# Wollongong Local Planning Panel Assessment Report | 29 March 2022

<b>WLPP No.</b>	Item No. 3
<b>DA No.</b>	DA-2021/1058
<b>Proposal</b>	Mixed use development - commercial and shop top housing
<b>Property</b>	Lot 2 Short Lane, HELENSBURGH NSW 2508
<b>Applicant</b>	Zta Group
<b>Responsible Team</b>	Development Assessment and Certification – City Wide Planning Team (RT)

## ASSESSMENT REPORT AND RECOMMENDATION

**ISSUE**  
**A**  
**JOB NO.**  
**20343**  
**DRAWING TITLE**  
SITE PLAN

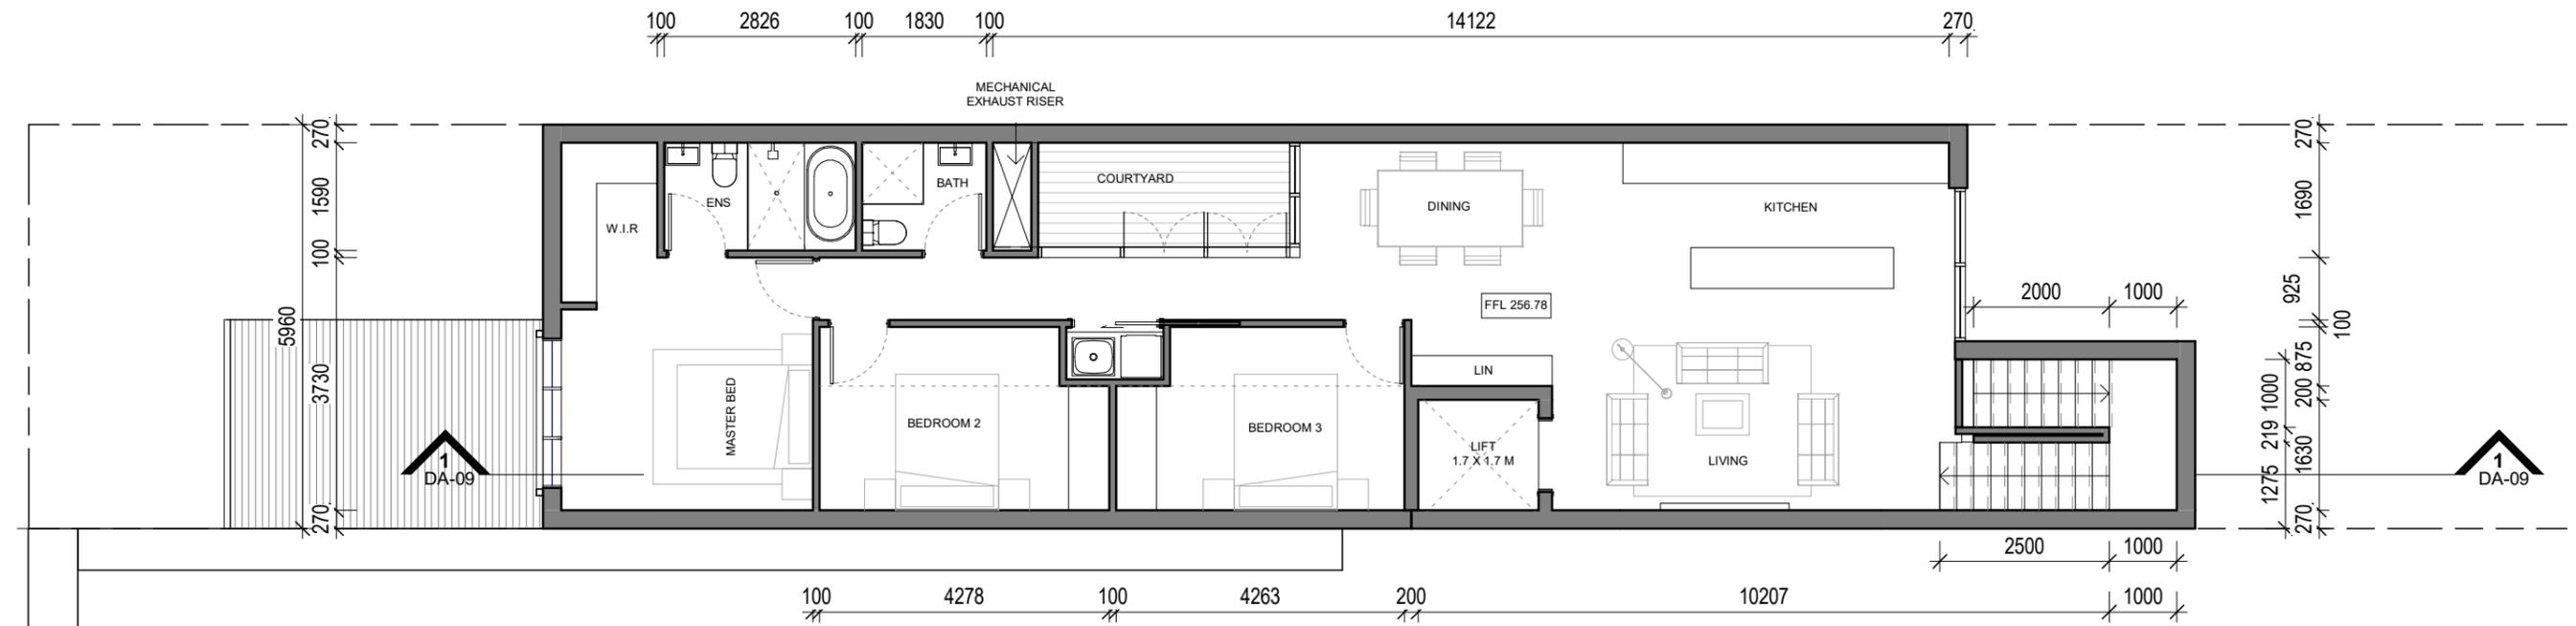
- Landscape Plan does not meet the minimum requirements set out in WDCP 2009 Chapter E6;
- There are contradictions between submitted plans and reports;
- The area of landscaping near Tree 1 differs in size and location on drawings DA-03 and DA-15;
- Lack of detail with streetscape treatment; the Landscape Plan and Site Plan are not coordinated. Report proposes porous concrete around tree 1 which is not shown on plans;
- Section 1 on page 24 of the arborist report shows a suspended slab above the FFL of the building. Positive drainage away from building would need to be achieved as well as equal access to entry; and
- Root mapping may also be beneficial.
